C/ 00 SC P L # 1001	CI 00 SC P L # 1002
Dallesasse, John	Dallesasse, John Emcore Corporation
Comment Type TR Comment Status A	Comment Type TR Comment Status R D2.0 comment
See John George's Comment #6 in recirculation package.	Per the vote in the November, 2004 meeting, the group needs to: ""demonstrate a 10-
SuggestedRemedy	12 BER over the rated distance on a specified channel (TBD) and show interoperability between PMDÆs of at least three vendors for 10GBASE-LRM to support technical
Per suggested remedy in George Comment #6.	feasibility prior to sponsor ballot."" This has not been done. The precedent
roposed Response Response Status C	established in IEEE 802.3ae can be synopsized by an excerpt from Jonathan Thatcher's comment regarding this topic that was submitted during 802.3ae balloting: ""Feasibility
ACCEPT IN PRINCIPLE.	means that technology must be demonstrated with reports and working models; proven

COMMENT STATUS: D/dispatched A/accepted R/rejected RESPONSE STATUS: O/open W/written C/closed U/unsatisfied Z/withdrawn SORT ORDER: Comment ID

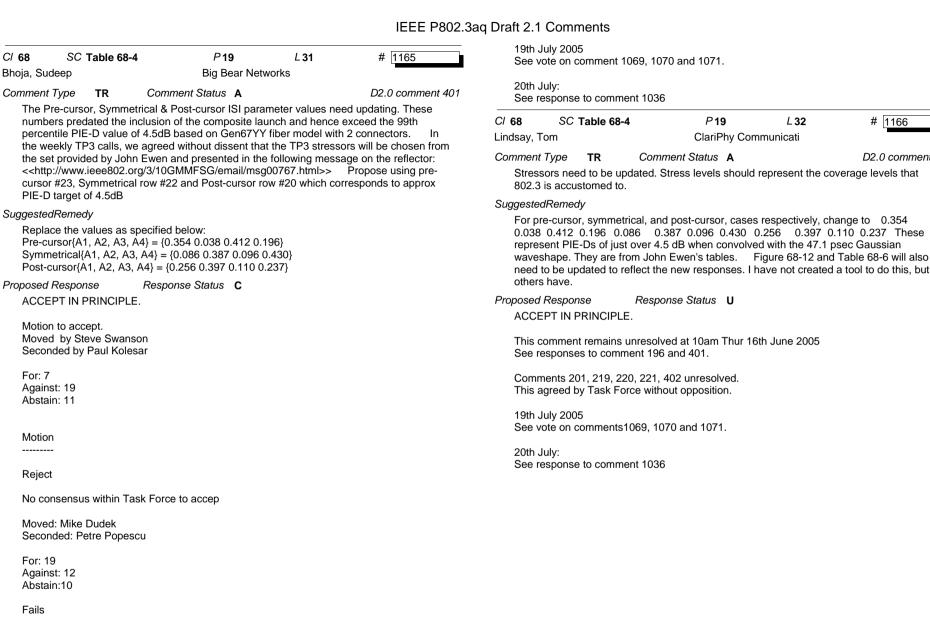
The 5dB value for the Transmitter Waveform Dispersion Penalty needs to be changed. Previous contributions such as lindsay 3 1104 have shown that TP2 & TP3 tests and limits should be linked. The PIE-D value for 99% coverage based on a 47.1ps reference Tx and Gen67YY fiber model with connectors is 4.5dB. This number is lower than the 5dB currently specified.

Change the 5dB value to 4.5dB
